CERTIFICATE OF APPROPRIATENESS

Property: 8011 Glen Valley Drive, lot 4, block 6, Glenbrook Valley Section 2 Subdivision. The property includes a historic 2,395 square foot brick single family residence situated on a 14,699 square foot (150, by 95') interior lot.

Proposal: Alteration – Replace 17 of the house’s original windows on the front and side elevations. This work has already been performed and was reported by a neighbor.

Recommendation: Denial - does not satisfy criteria

WINDOW PLAN
PROPOSED

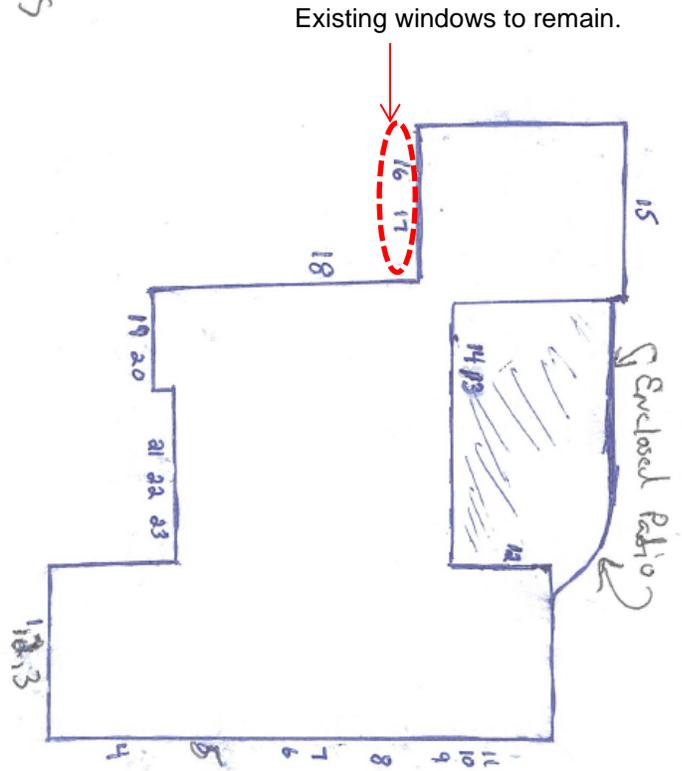
<i>The removal of 17 original windows fails to retain the historic character of the structure.</i> |

<i>The historic aluminum framed windows were a distinctive quality of the residence. Their removal results in the historic character of the residence being compromised.</i> |

<i>The 17 original windows were a distinctive stylistic exterior feature of the residence. Removing all of them fails to maintain these features.</i> |

<i>Removal of the 17 original windows represent a substantial loss of historic material. They were removed prior to a complete staff inspection of their condition. Without this inspection, there is no way to determine if the windows were damaged to warrant removing all of them.</i> |

WINDOWS 1, 2, AND 3 - FRONT FACING GLEN VALLEY DRIVE
PREVIOUSLY EXISTING

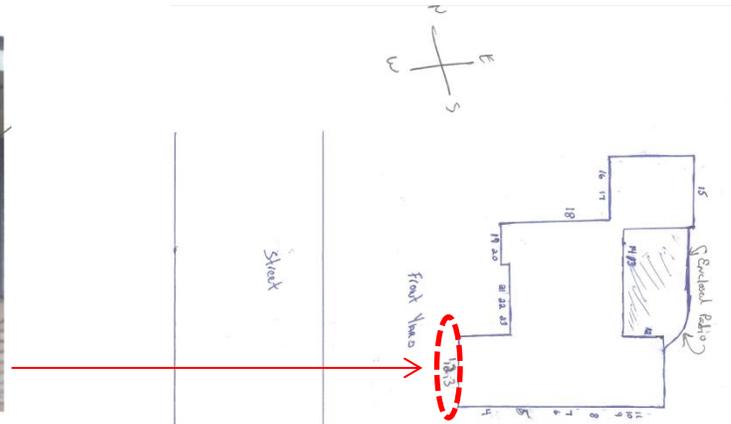
Front Elevation (West): Viewing the house from the street, Windows 1, 2, and 3 were a contiguous row of metal 1 over 1 windows on the right side of the front elevation. These were replaced with matching vinyl windows.

**WINDOWS 21, 22, AND 23 – FRONT FACING GLEN VALLEY DRIVE
PREVIOUSLY EXISTING**

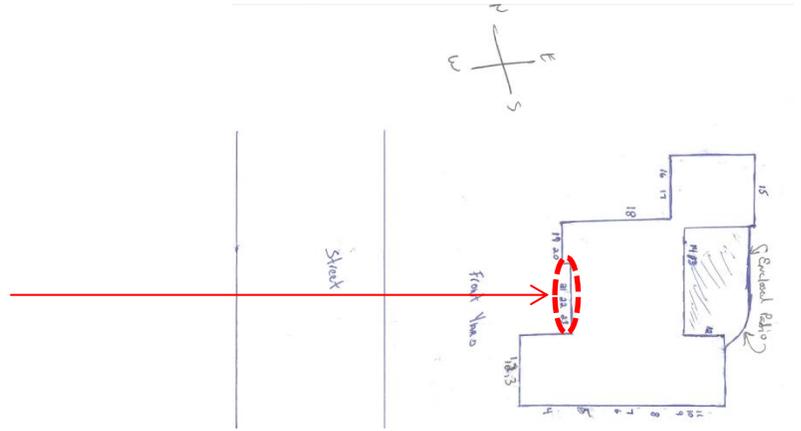
Windows 21, 22, and 23 were the metal framed picture window flanked by a pair of 4 lite horizontal lite windows. These were replaced with a vinyl picture window flanked by a pair of 1 over 1 vinyl windows installed within the existing window openings.

WINDOWS 19 AND 20 – FRONT FACING GLEN VALLEY DRIVE
PREVIOUSLY EXISTING

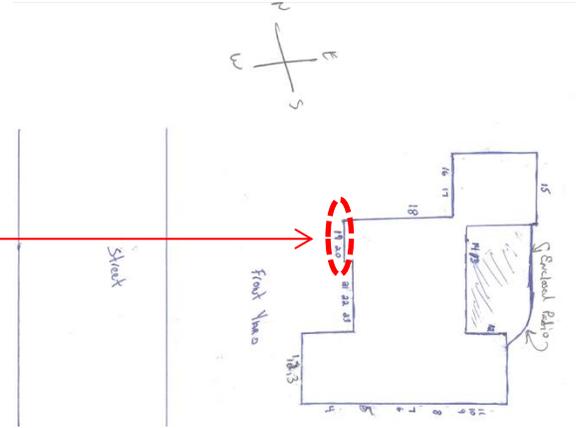
Windows 19 and 20 were a pair of 4 lite horizontal lite metal windows on the left side of the front elevation. These were replaced with vinyl 1 over 1 windows installed within the existing window openings.

WINDOW 4 – FACING SOUTH SIDE PROPERTY LINE

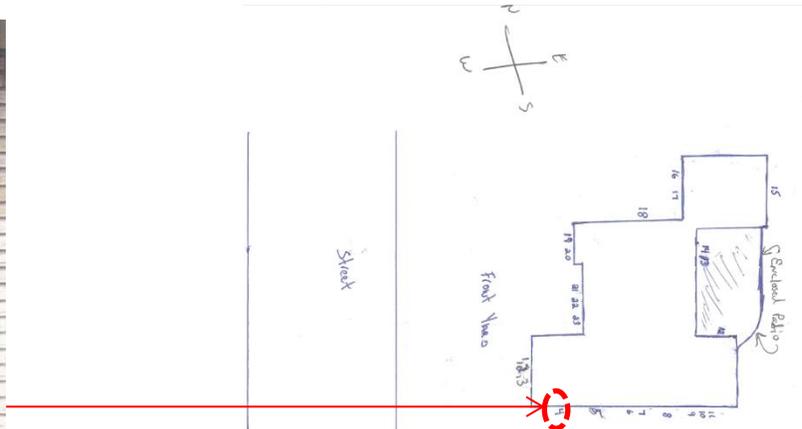
Side Elevation (South): Viewing from front to back: Window 4 was a 4 lite horizontal lite window. It was replaced with a vinyl 1 over 1 window installed within the existing opening.

WINDOW 5 AND 8 – FACING SOUTH SIDE PROPERTY LINE

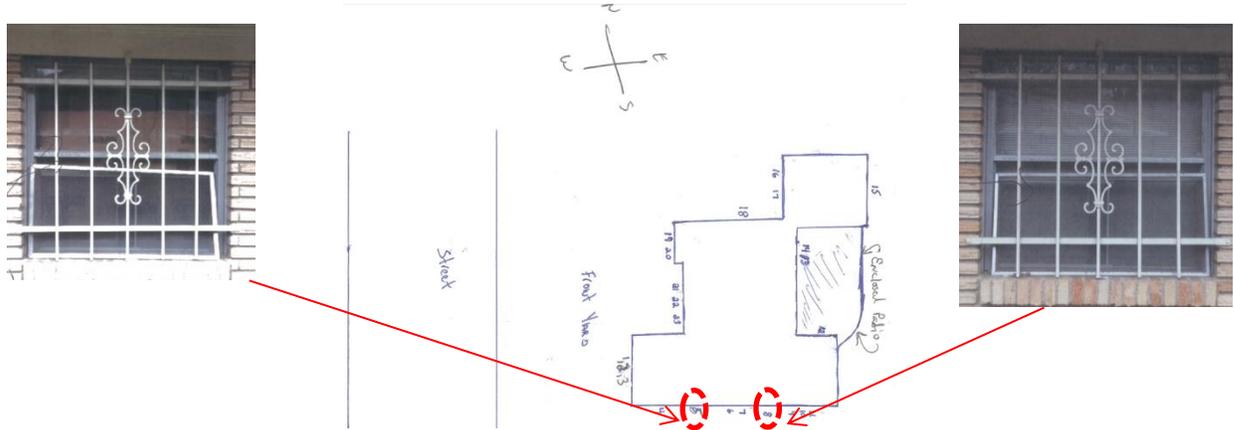
Windows 5 and 8 were 1 over 1 metal windows. They were replaced with matching vinyl windows.

WINDOWS 6 AND 7 – FACING SOUTH SIDE PROPERTY LINE

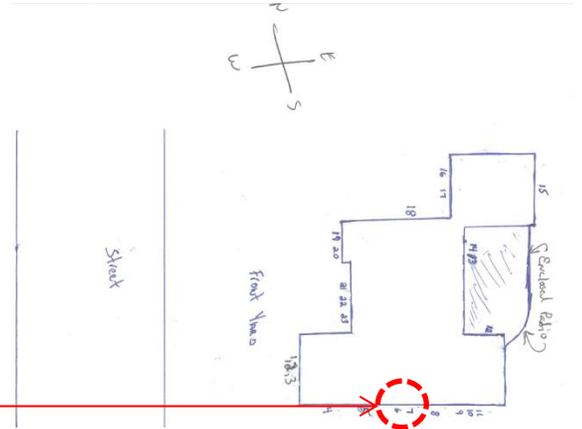
Windows 6 and 7 were 4 lite horizontal lite metal windows. They were replaced with vinyl 1 over 1 windows installed within the existing openings.

WINDOWS 9, 10, AND 11 – FACING SOUTH SIDE PROPERTY LINE

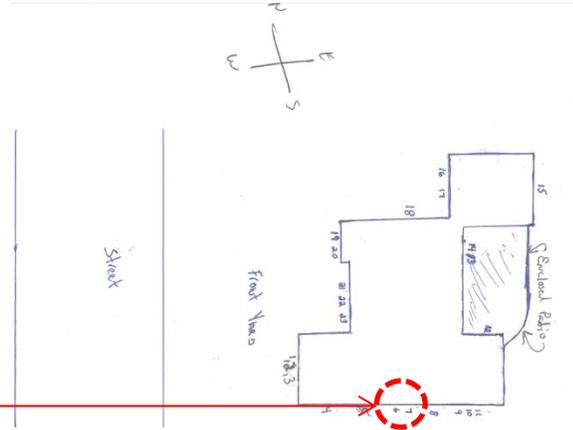
Windows 9, 10, and 11 were a contiguous row of metal 1 over 1 windows. These were replaced with matching vinyl windows.
